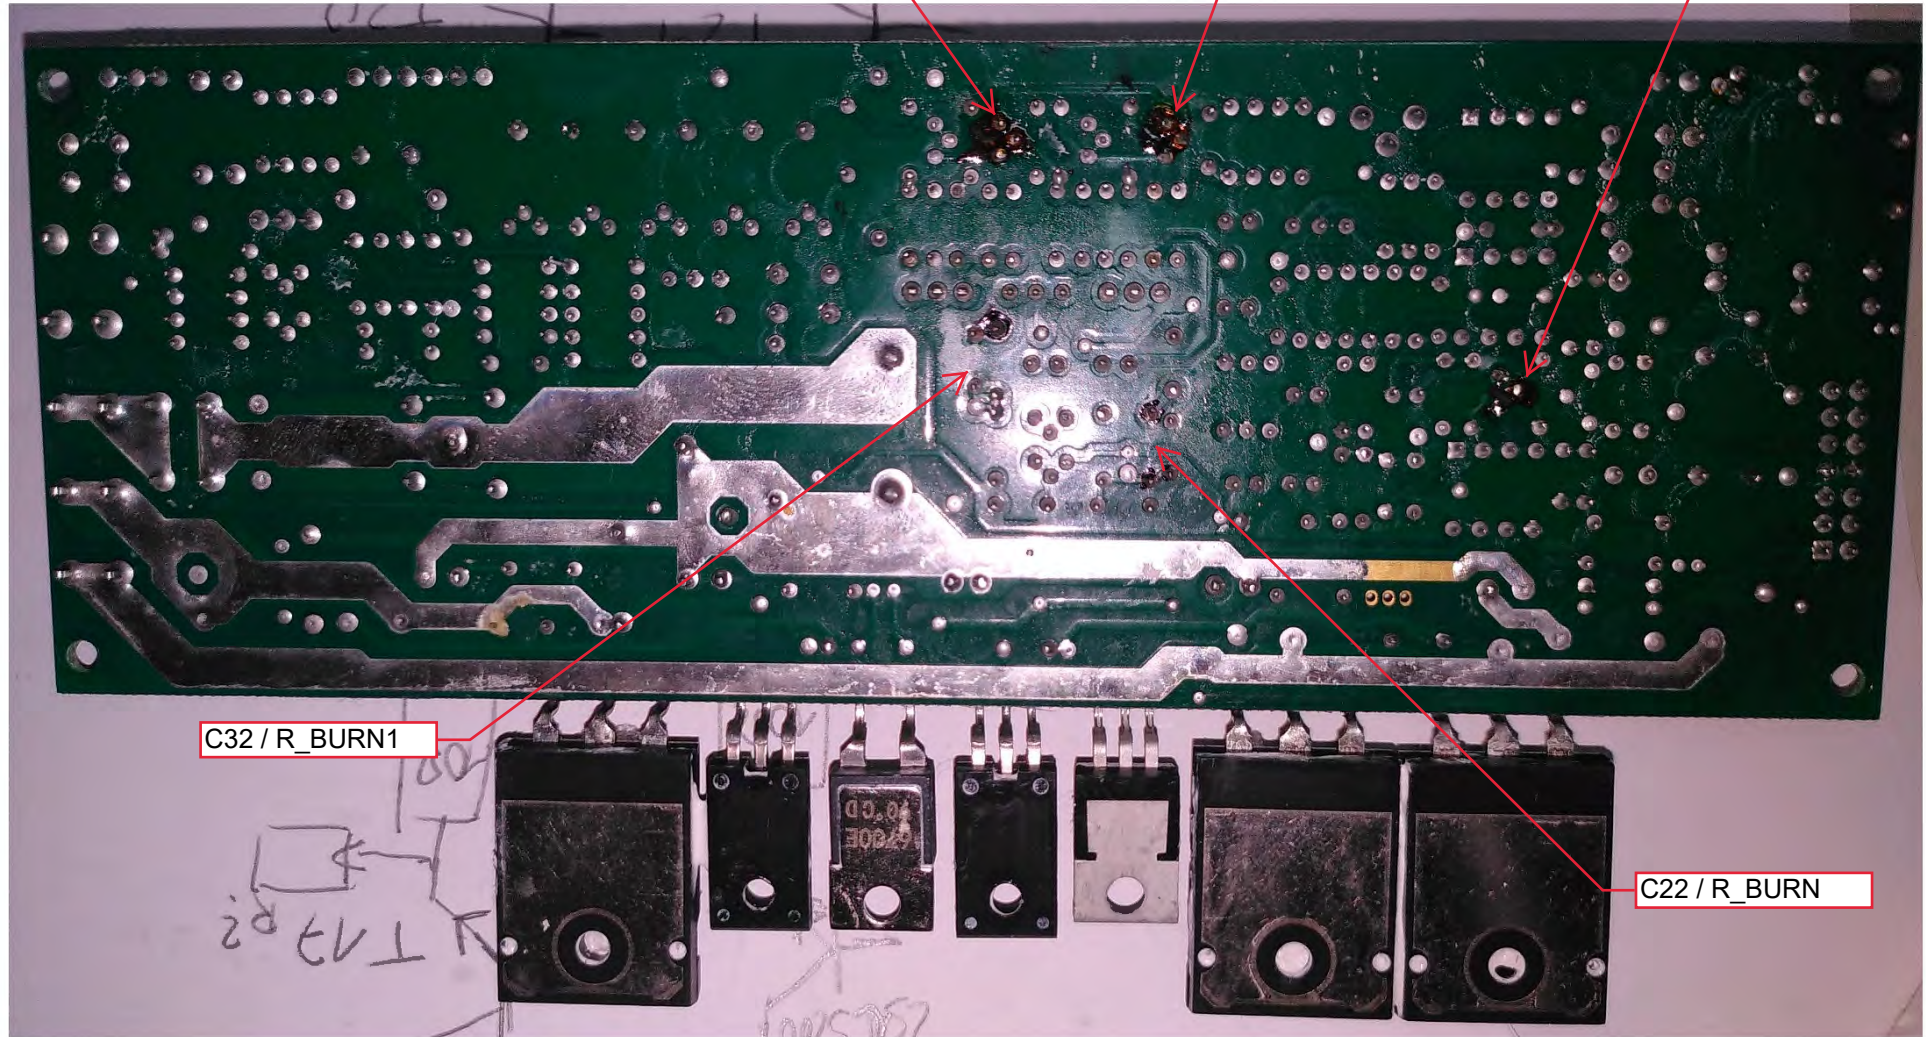
T17 solder joints
look strange, but
transistor seems
ok

T18 complete short

T13 complete short

T14 complete short

T15 complete short

T21 complete short

Thermal switch -->
closed contact

T20 already
removed by me,
seems ok

T3 solder joints seem to have gotten hot.

T9 solder joints seem to have gotten hot.

bodge SMD transistor T1 from someones previous repair ?

C32 / R_BURN1

C22 / R_BURN
